AMENDMENT TO LEASE 5574.1
GENERAL LEASE - INDUSTRIAL USE

Project Title: Chevron El Segundo Groin and County Outfall
Extension

MITIGATION *

* Prepared in response to comments on the "Initial Study, El Segundo Marine Terminal (ESMT) Protection Project, El Segundo Refinery, For Chevron U.S.A., Inc.", by Dames and Moore, March 1, 1983.

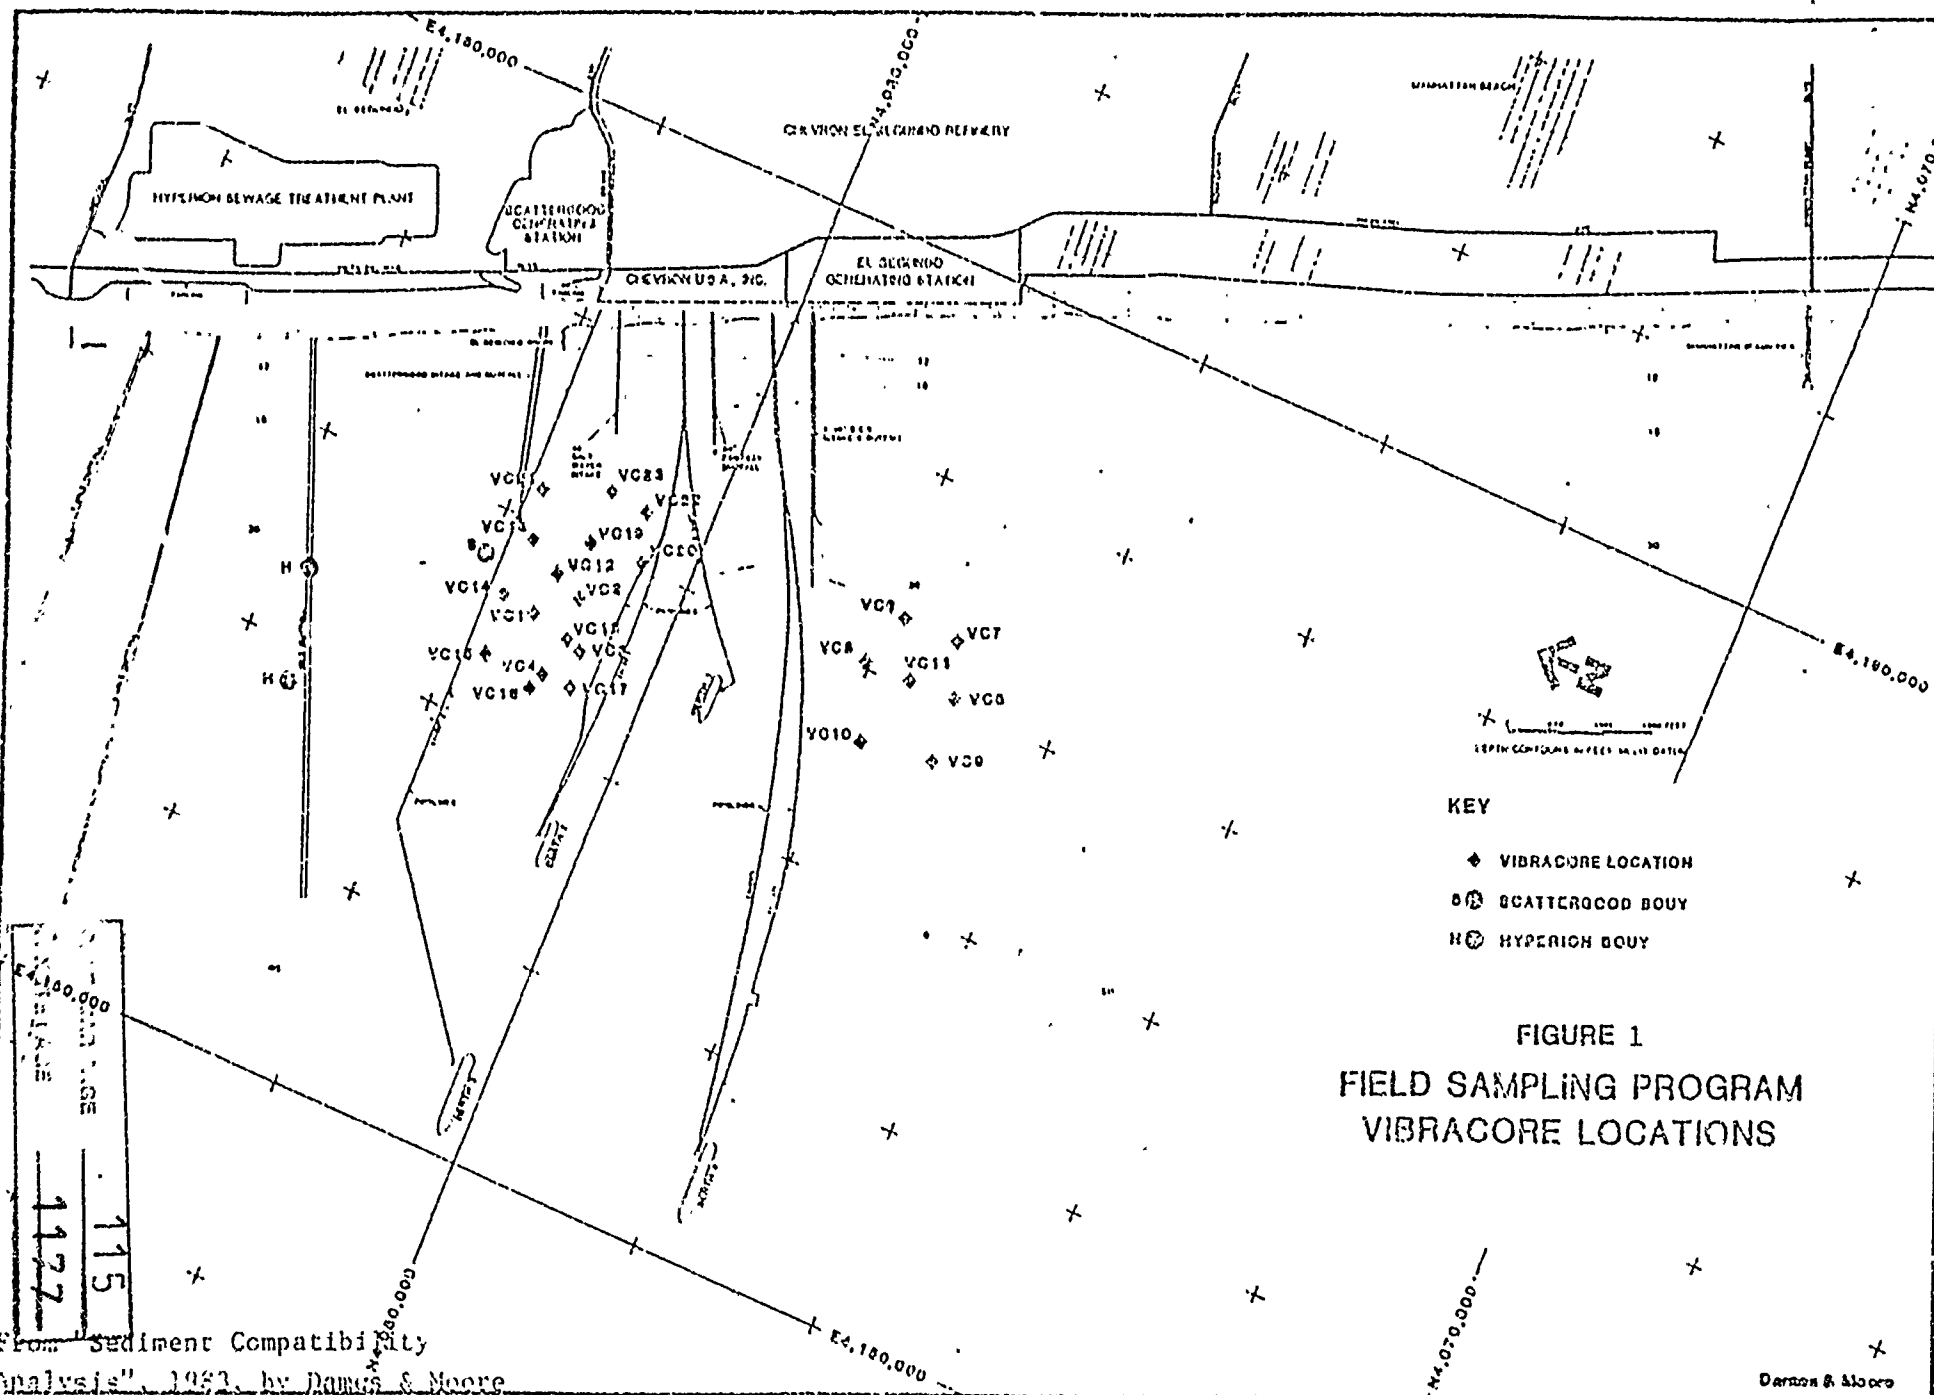
The question was raised of the compatibility of the borrow source material for the beachfill site. As mentioned previously, Dames and Moore made a sand compatibility study based on a program of 24 offshore core samples in December 1982 and January 1983. This report was submitted to the U.S. Army Corps of Engineers (COE) in March 1983. Following is a summary of the results of this report.

Figure 1 presents a drawing of an outline of the proposed borrow area with north-south and east-west cross-sections. This outlined surface area represents approximately 284,000 square yards. Sixteen vibracores between 3½ and 11 ft in length were obtained from this area. This number is in excess of the 11 vibracores required by the following formula presented in the COE guidelines:

(where N is the required maximum number of vibracores and A is the surface area of proposed dredging in square yards.)

FIGURE 8: ESTIMATED OCEAN BOTTOM DEPTHS, A COMPARISON

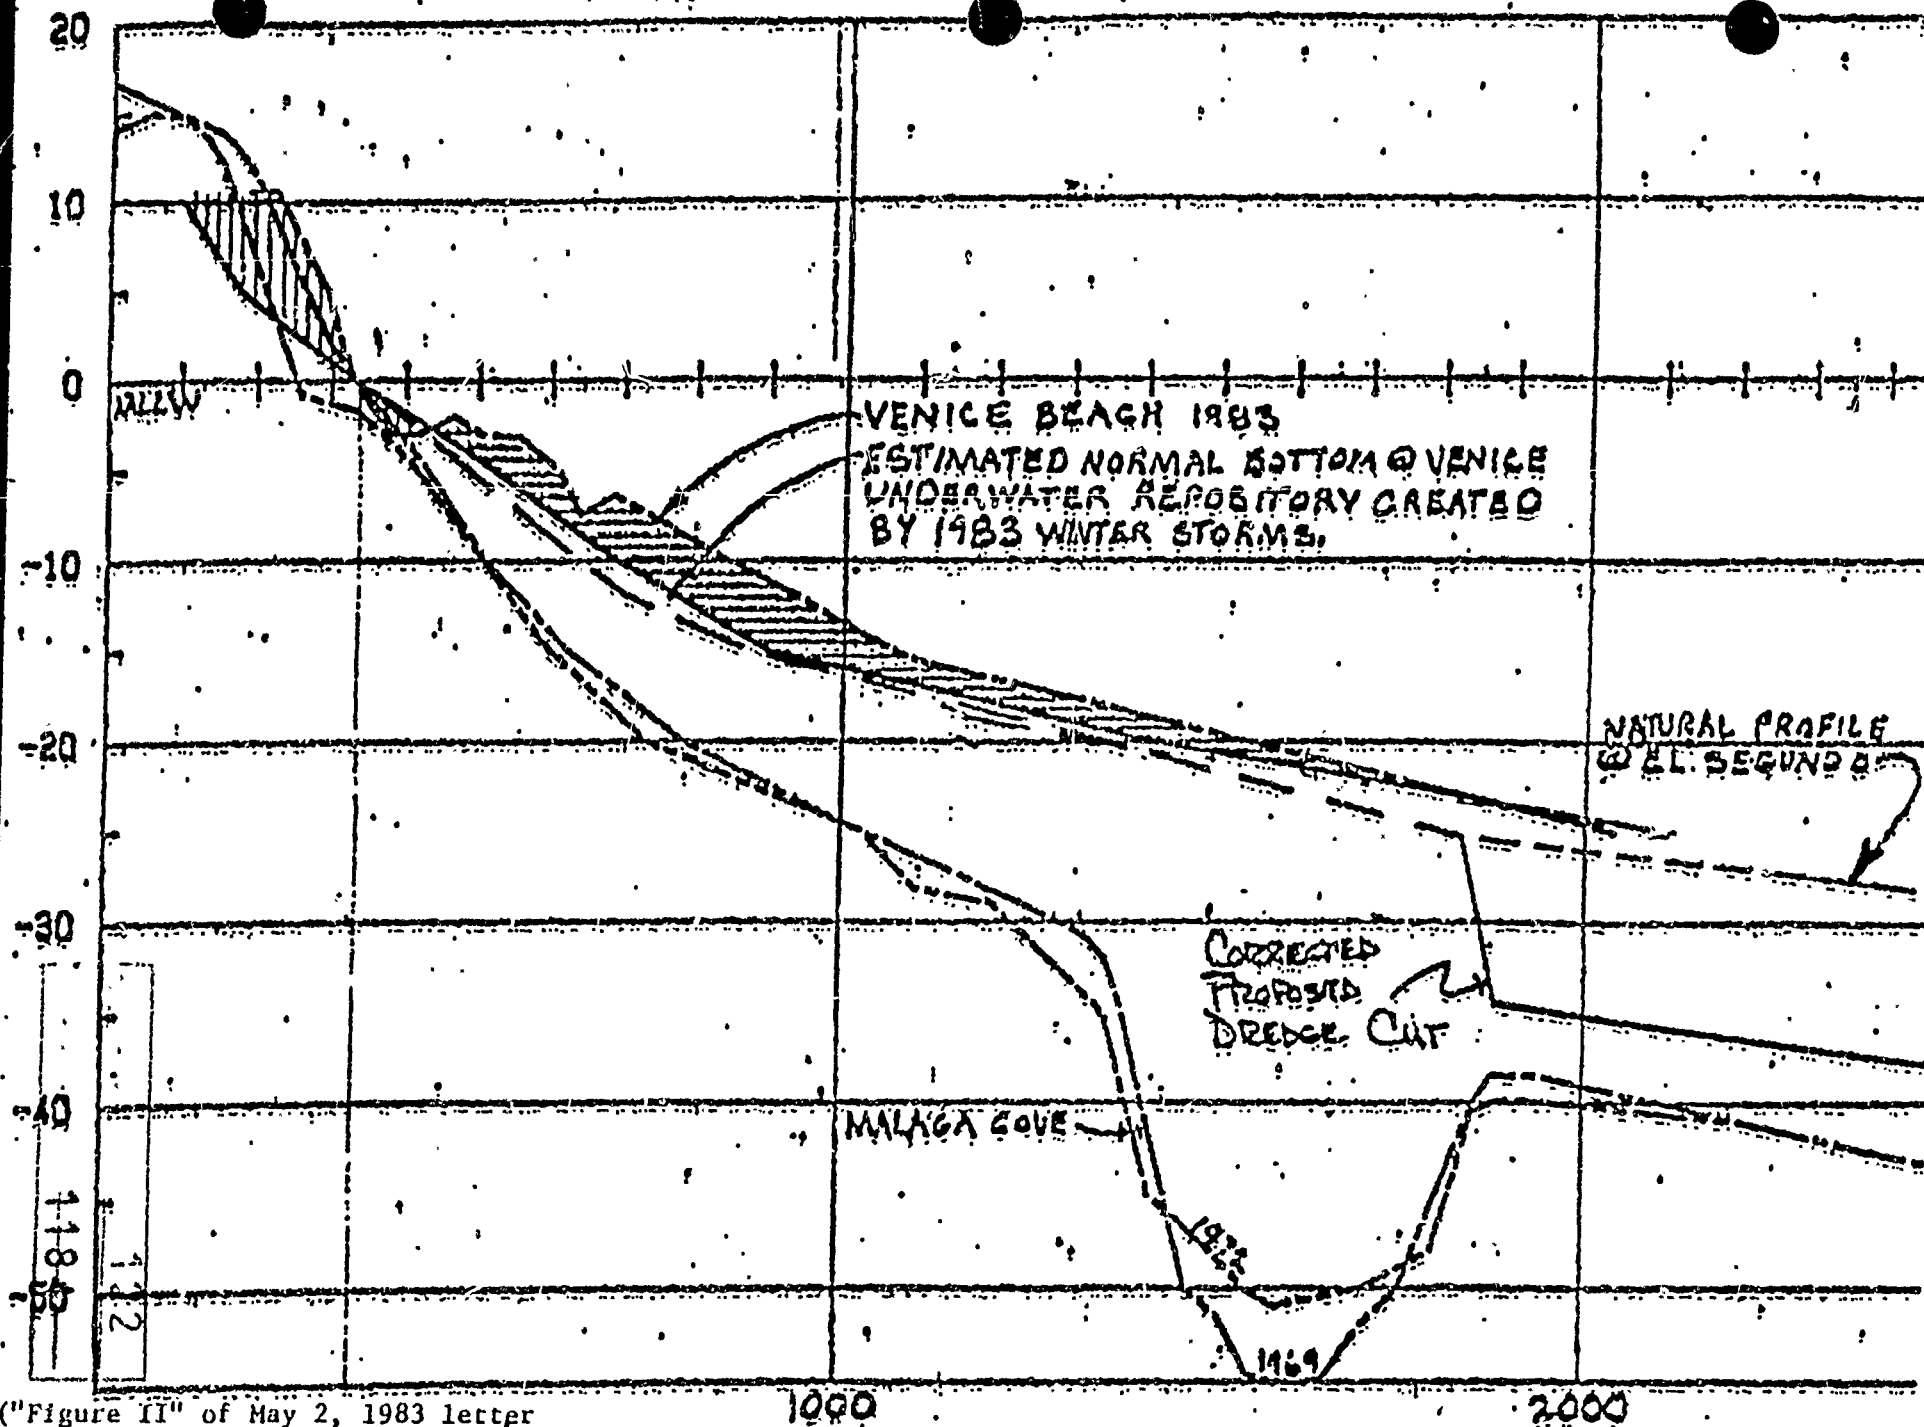
Concern has been expressed that the dredge borrow site is located too close to shore and will fill in with material drawn offshore from the beach fill. This would cause a deficit in sand carried in the longshore transport system, which would potentially result in increased down coast erosion. In support of this concern Los Angeles County Engineer - Facilities Department prepared several profiles depicting the Redondo-Malaga Cove dredge depression, the proposed El Segundo dredge depression and pre and post 1983 storm profiles near Venice beach (see Figure 8). In preparing the Figure, the County states that the Initial Study presents conflicting data on the inshore limit of the proposed dredge source. Since this data was used to formulate their conclusions, the following paragraph is presented to clarify the data.

The County's report refers to Page 64 of the Initial Study which indicates -25 ft MLLW at 1250 feet, while Figure 19 (from Initial Study) indicates -30 MLLW. The inshore limit of the proposed dredge cut is defined as -25 ft. MLLW. The length of the beach parallel dredge cut (north to south) is approximately 1,250 ft. This is not the distance from the shoreline (which presently is approximately 1,500 ft from the shoreline to the inshore limit of the dredge cut). The County selected Figure 19 from the Initial Study, to base their profiles of the proposed El Segundo dredge cut. Since this is a schematic drawing, scaling data from this figure is inappropriate. Chevron has have revised the County's Figure II (see Figure 8 of this report) to reflect a correct representation of the proposed dredge cut profile.

As shown on Figure II, a considerable amount of material has been drawn offshore Venice beach as a result of the 1982/1983 winter storms. The seaward limit of this storm includes offshore movement of material is shown in Figure 8 to be approximately -22 ft MLLW and only a small fraction (5 percent) of the total volume is seaward of -20 ft MLLW. Since the dredge cut will be seaward of -25 ft MLLW, there is little chance that any significant offshore transport of material will be drawn into the dredge depression by storm events and not returned to the active littoral zone. The profiles presented by the County for Venice beach are typical of profiles we have examined in Santa Monica Bay that all indicate the seaward limit of active on-offshore littoral movement is in the range of -17 to -22 ft MLLW. The shoreward limit of dredge cut was selected after examination of historical beach profiles, wave data and operational limits of available dredging equipment.

CHAIN-LINK FENCE TO BE LOCATED APPROX. 50 FT. OFFSHORE OF NORTH SIDE OF ROCK GROIN

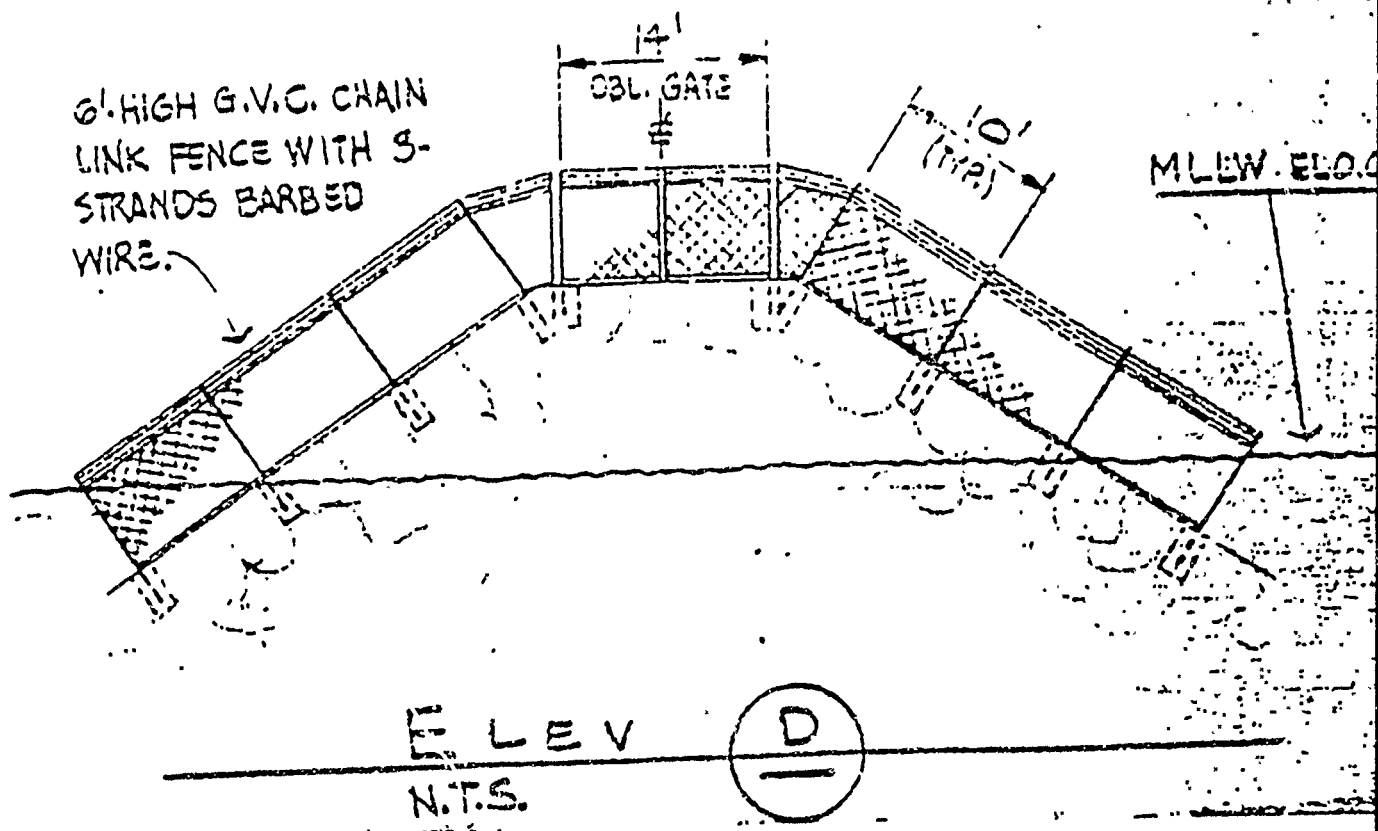
It was pointed out that the groin will constitute an "attractive hazard" if there is access to the structure by the public, and that maintenance and liability responsibilities should be clearly specified. Chevron is constructing a privately-owned structure specifically to protect their own private property being threatened by ocean erosion. As such, it is in Chevron's interest and is their intent to maintain the groin so that it continues to perform its intended function. To minimize the "attractive hazard" aspects of the structure, a 6-foot high chain link fence will be constructed approximately mid-way in the length of the groin to minimize the possibility of access to parts of the groin adjacent to and in contact with the sea. In addition, a guard rail and chain will be located at the shoreward end of the groin to prevent bicyclists from gaining easy access to the top of the groin. These two security structures are shown in attached Figures 9 and 10. Chevron will assume liability for construction and maintenance of the groin, and will provide the County and/or State with documentation releasing them from any such liability.
